Reviewed for Code Compliance  
Inspections Division  
Approved with Conditions

# 57 COYLE STREET RENOVATION

COVER SHEET

Re: Renovation to Cabot Residence  
57 Coyle Street  
Portland, Maine

1 STAIR DETAIL  
3/8" = 1'-0"

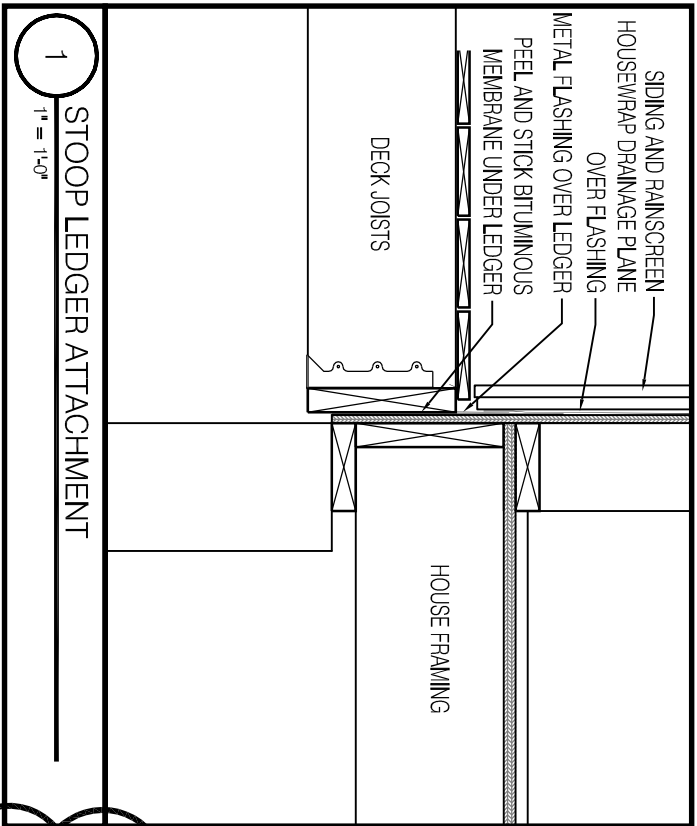
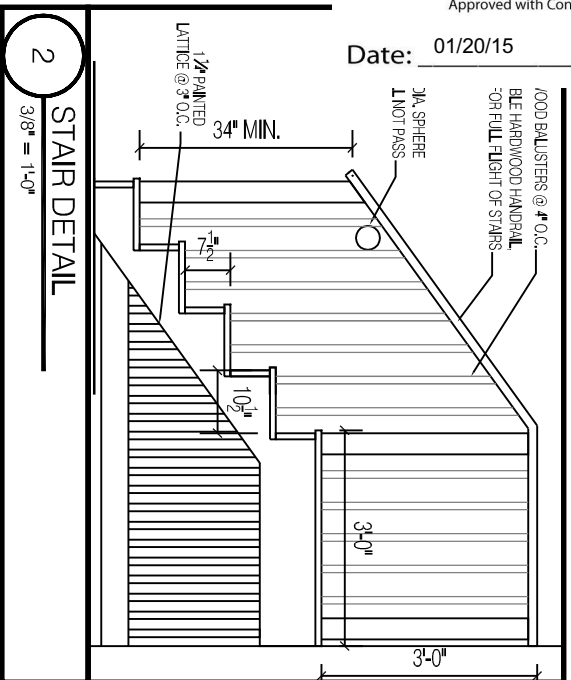
IRC Sec R311.7.4.3  
requires the nosing to  
be a minimum  
of 3/4" and a max  
1-1/4"

1 STOOP LEDGER ATTACHMENT  
1" = 1'-0"

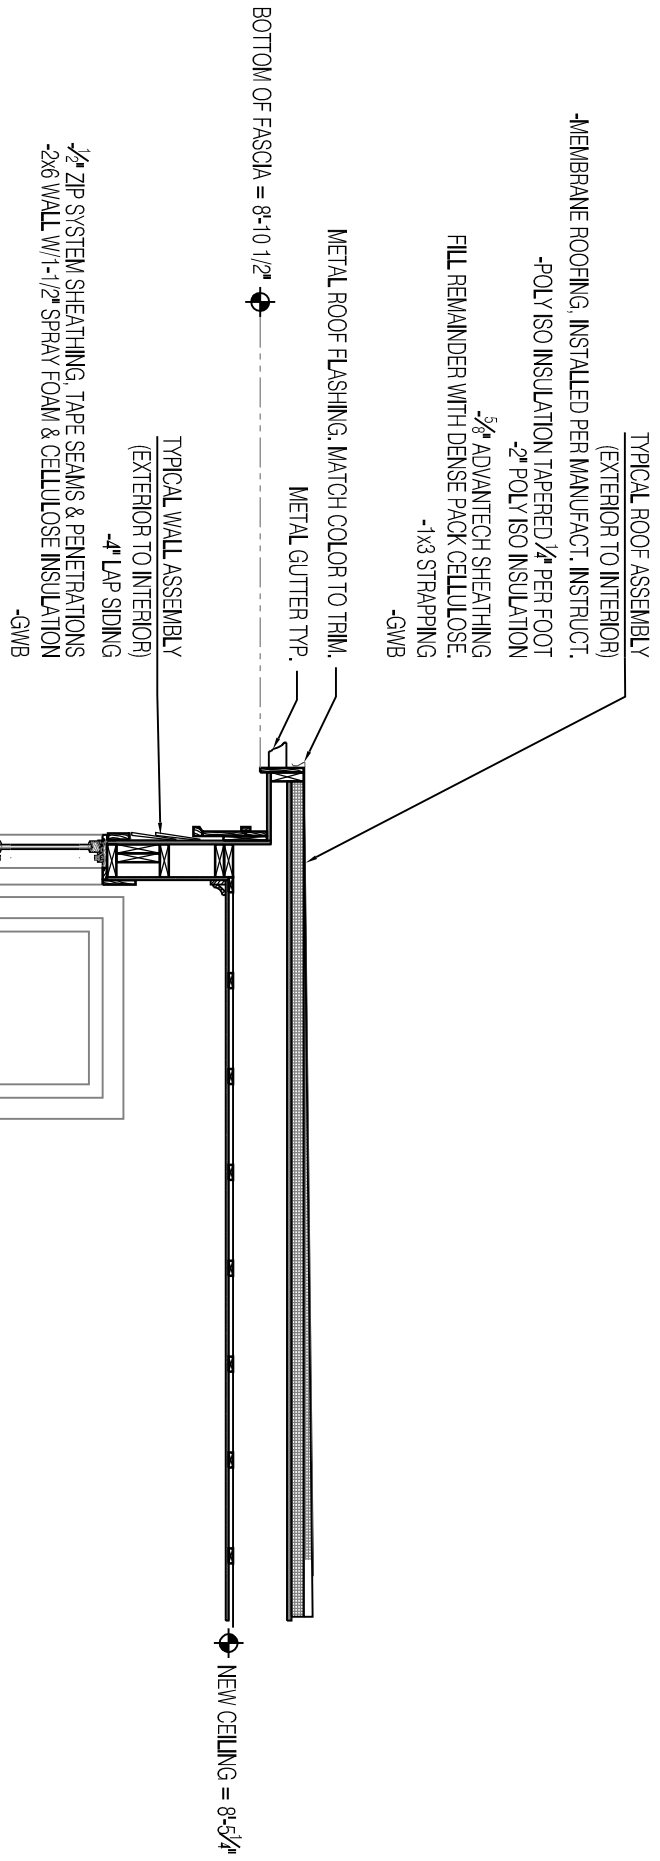
Frost protection shall be provided as per  
the typical footing detail below
